HISTORIC AND DESIGN REVIEW COMMISSION

November 04, 2020

HDRC CASE NO: 2020-481
ADDRESS: 135 W ROSEWOOD AVE
LEGAL DESCRIPTION: NCB 6534 BLK 14 LOT 1&2
ZONING: R-5,H
CITY COUNCIL DIST.: 1
DISTRICT: Monte Vista Historic District
APPLICANT: Kristy Kosub
OWNER: Kristy Kosub
TYPE OF WORK: Front walkway replacement
APPLICATION RECEIVED: October 01, 2020
60-DAY REVIEW: Not applicable due to City Council Emergency Orders
CASE MANAGER: Stephanie Phillips

135 W. ROSEWOOD

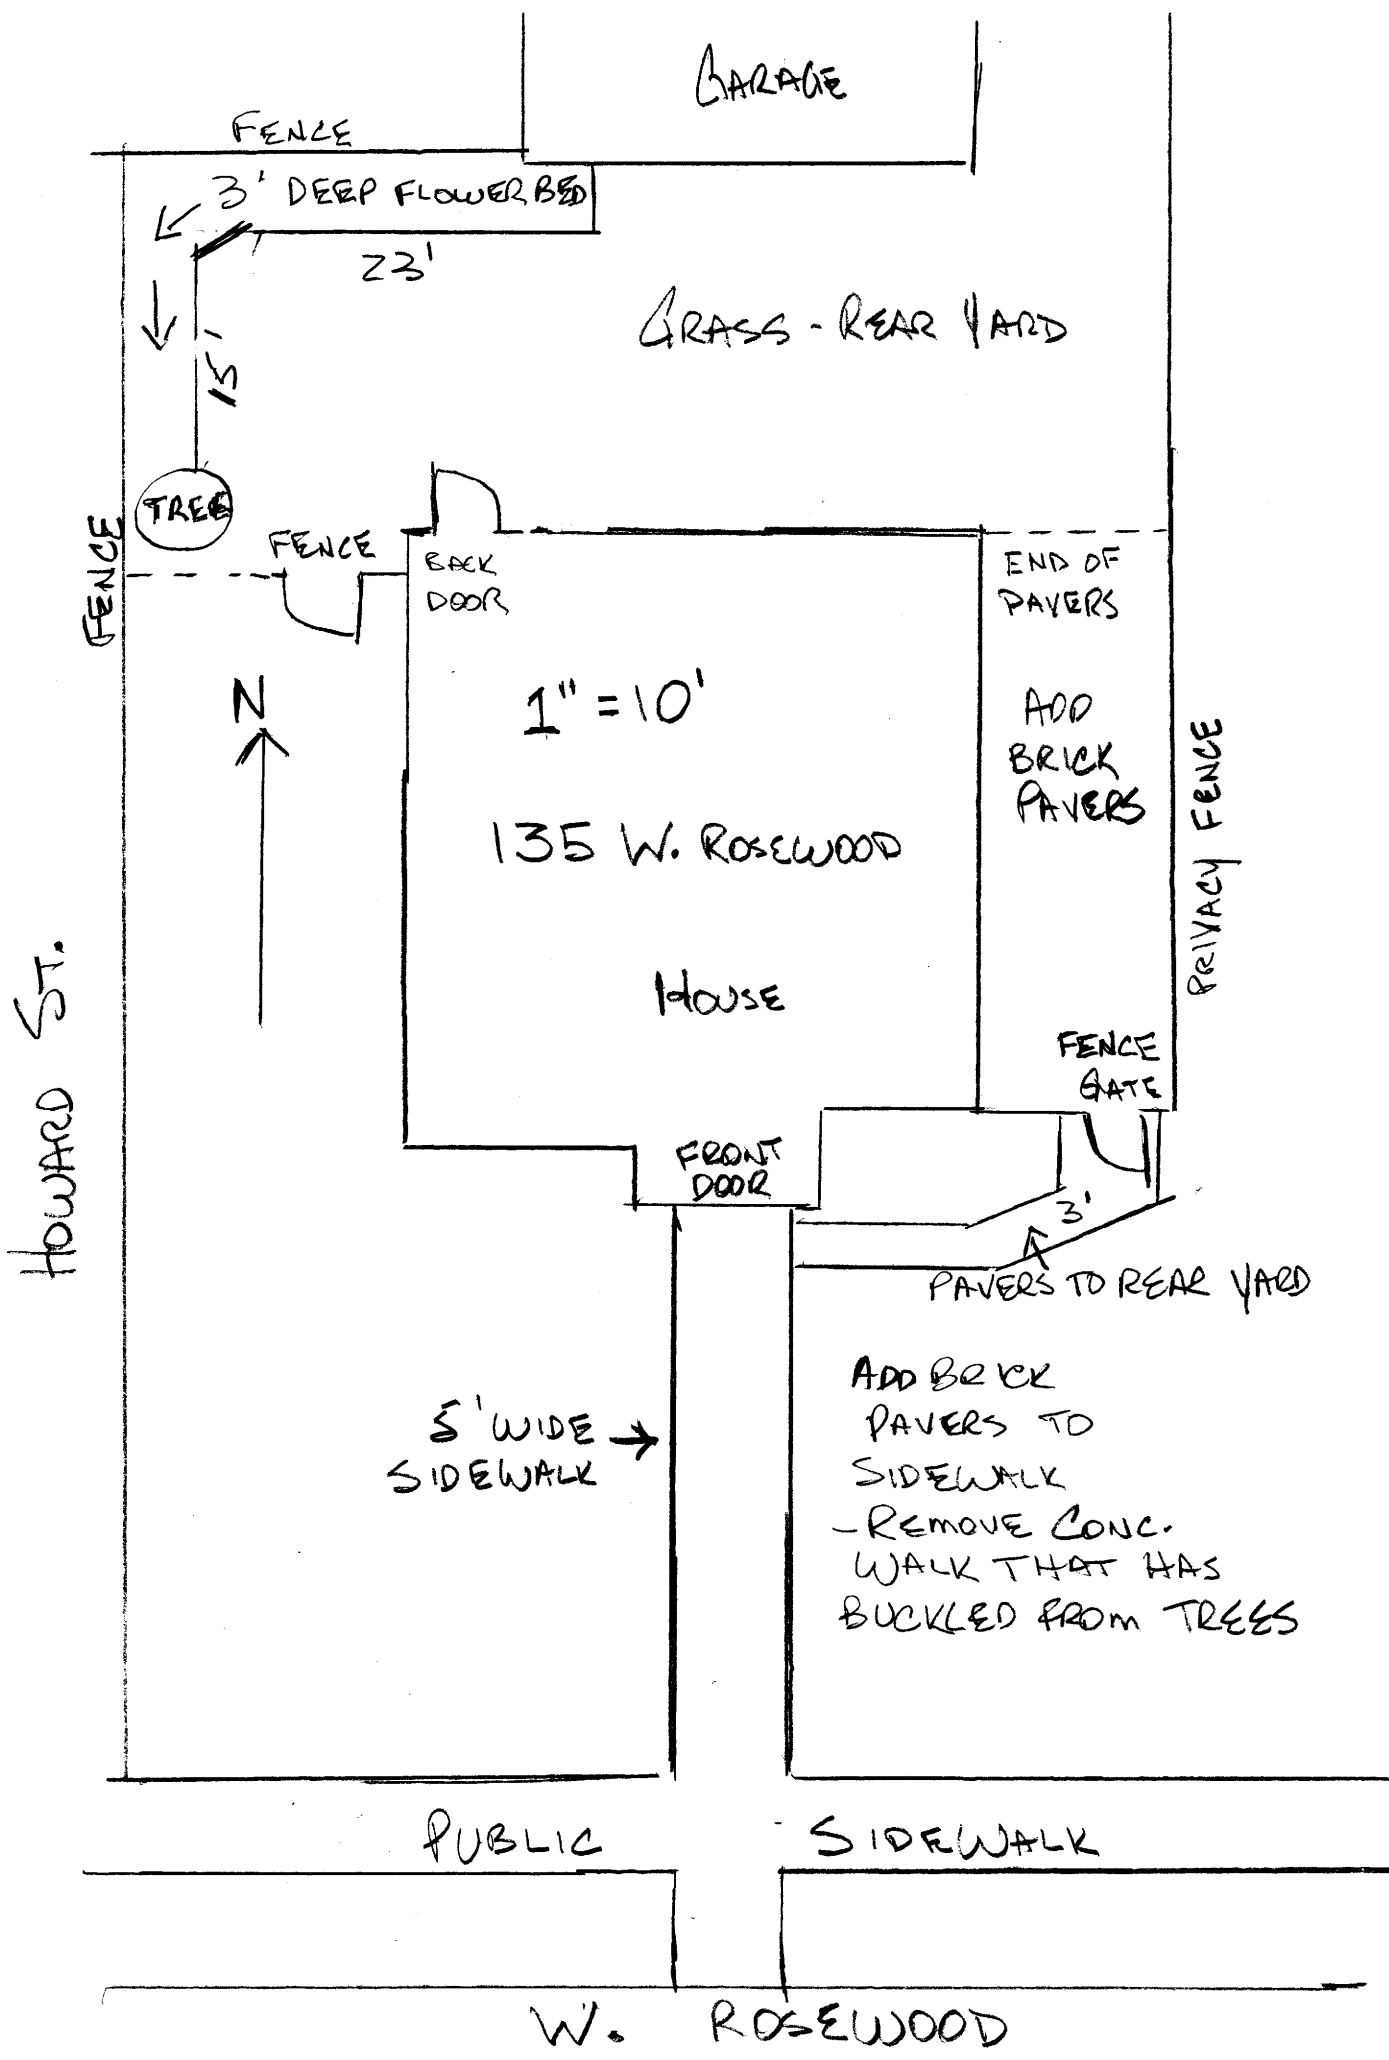
- b. **WALKWAY** – The applicant is proposing to remove the existing continuous concrete walkway leading from the street to the porch with a walkway constructed of individual gray bricks. Per the applicant, the existing walkway is sinking and in need of replacement. According to the Historic Design Guidelines, walkways should be replaced in-kind and follow the historic alignment, configuration, and width of those historically found in the district. The historic width, alignment, or design should only be altered where absolutely necessary to accommodate the preservation of a significant tree. Staff does not find the proposal consistent with the Guidelines.

- c. **ADMINISTRATIVE APPROVAL** - The submitted request also includes adding a 3 foot wide secondary walkway of gray bricks from the existing walkway to the side fence line, near the front facade of the house, as well as bricks in a portion of the rear yard behind the privacy fence. Based on the width and location, staff finds this portion of the request eligible for administrative approval.

Staff does not recommend approval based on in finding b. The repouring of the walkway in-kind is eligible for administrative approval.
